CORPORATE AUTOMOTIVE BULLETIN

Subject: Landi Renzo Starter Interrupt Relay Improvement Kit

Bulletin #: D22-01 OP Code # 48

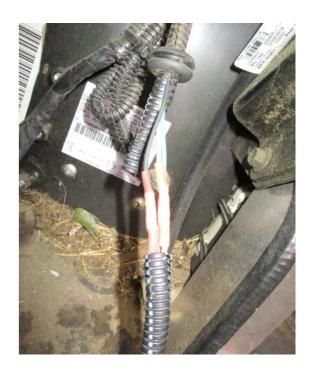
1. To install locate the existing relay housing located on the left lower dash support and remove it from the support with the 2 outermost (1) Philips screws. Then remove the 4 Philips screws (2) to open the housing to expose the relay.
